Applicants request a Special Exception under Section 2.16.050 J (Carport over a Driveway) in an R-3 (Residential) zone.

**TO:** Zoning Board of Adjustment Staff  
**FROM:** Juan Estala, Building Plans Examiner, Building Permits and Inspections Division  
**SUBJECT:** CARPORT CASE FOR October 24, 2011 ZBA MEETING  
**DATE:** 10/17/2011

NEW CARPORT FOR  
 Carlos R & Guadalupe Cs  
 10181 Saigon Drive El Paso  
 SHEET TITLE: NEW EXTERIOR CARPORT AND CITY PERMIT APPLICABLE  
 MASTER PLAN DESIGNS  
 ENGINEER: [Signature]  
 DATE: 01/25/11

1 SITE PLAN  
 SCALE: 1/8" = 1'-0"

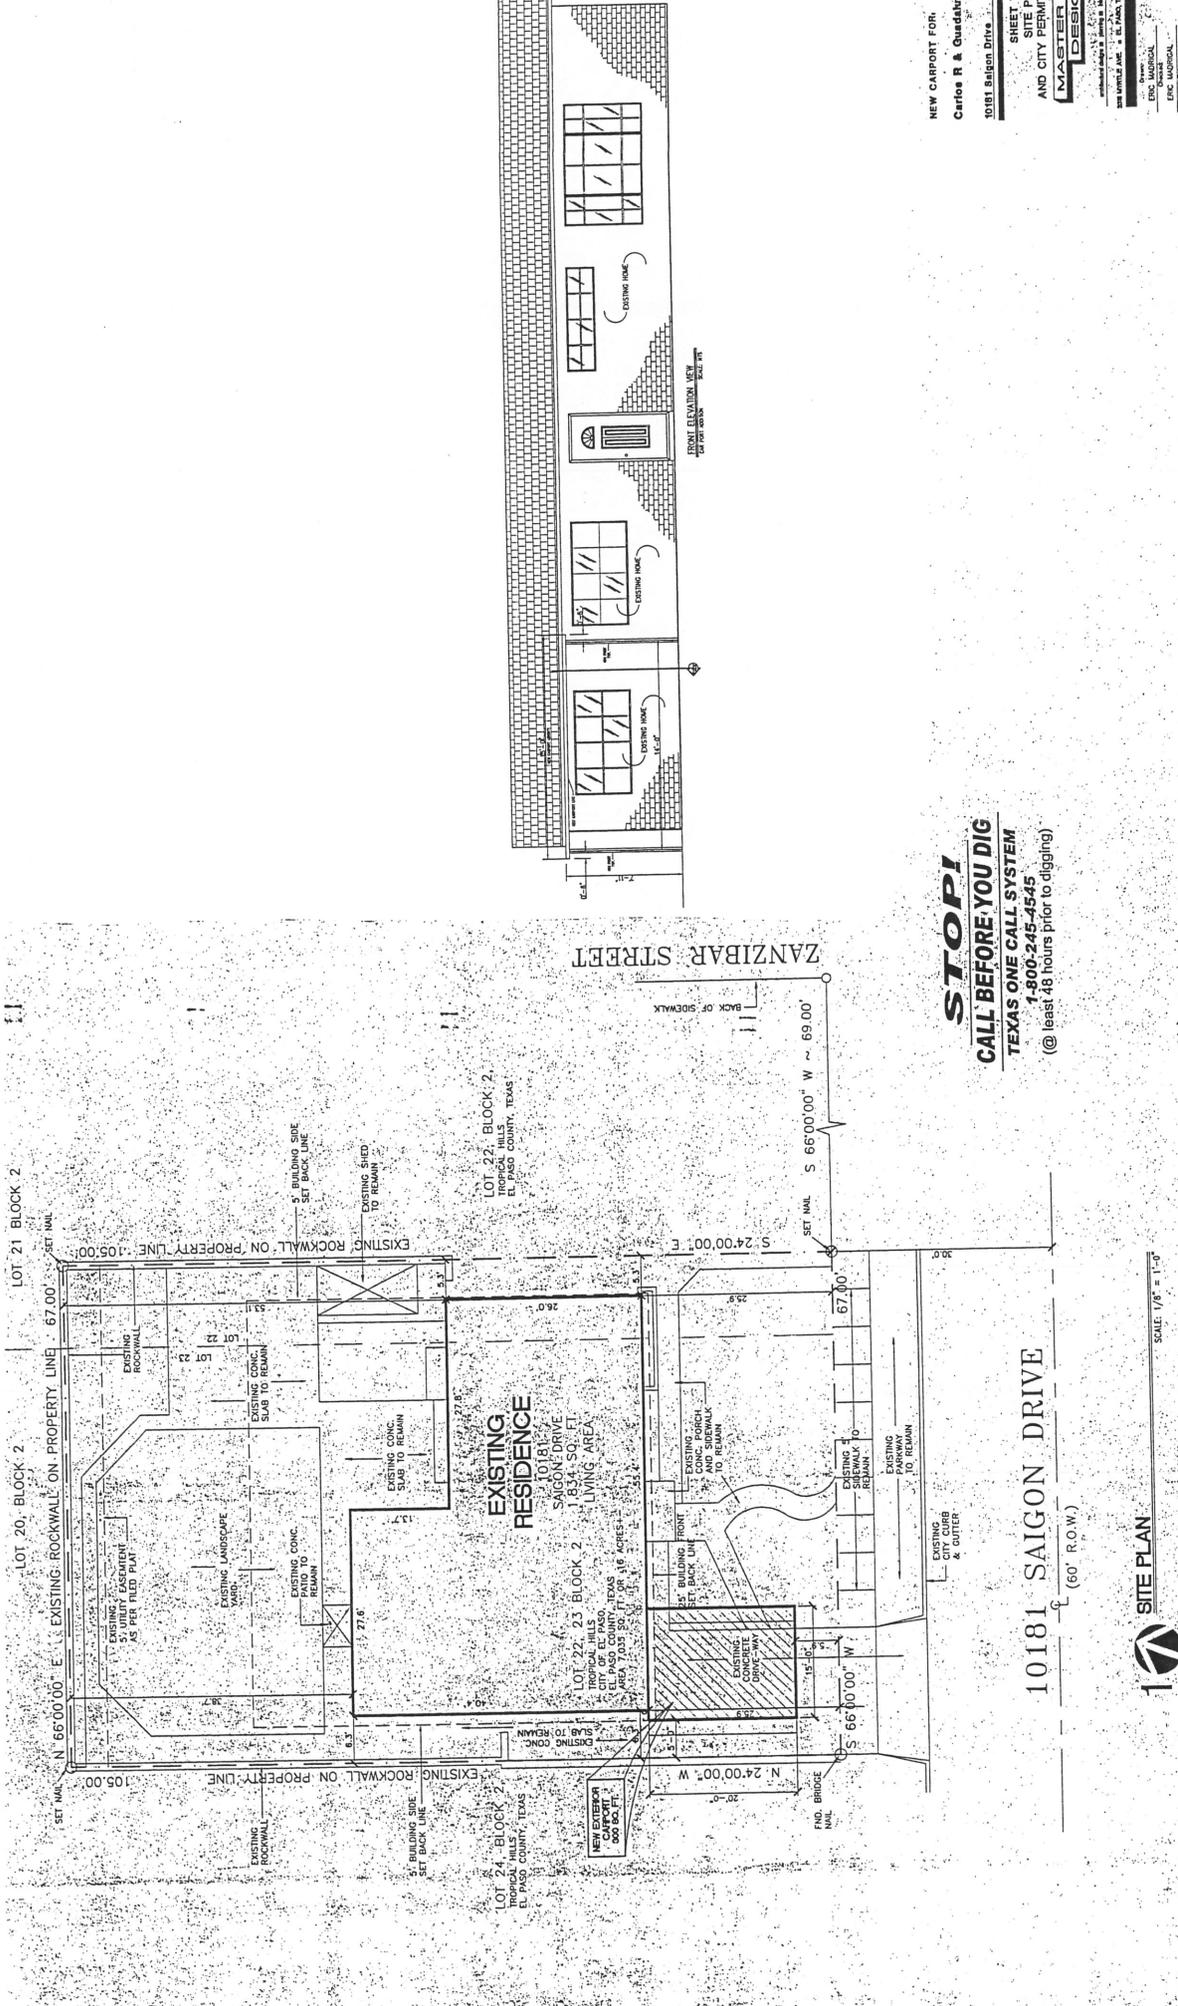
This case was postponed from the October 24, 2011 meeting to allow the applicant to submit a revised site plan that shows all curb cuts for driveways, revised structural drawings that accurately reflect the location of the carport and an architectural design to match the house.

The applicant submitted a carport design with a flat roof that does not rise higher than the roof of the house with roof materials and paint to match the existing house. There is no utility easement at the front property line. The Engineering & Construction Management Department has reviewed the structural plans and found them acceptable. Staff suggested to the applicant that the carport design be changed to a pitched roof and to include columns faced with brick to match the house.

The carport's structural design has been reviewed and has been found to be acceptable.
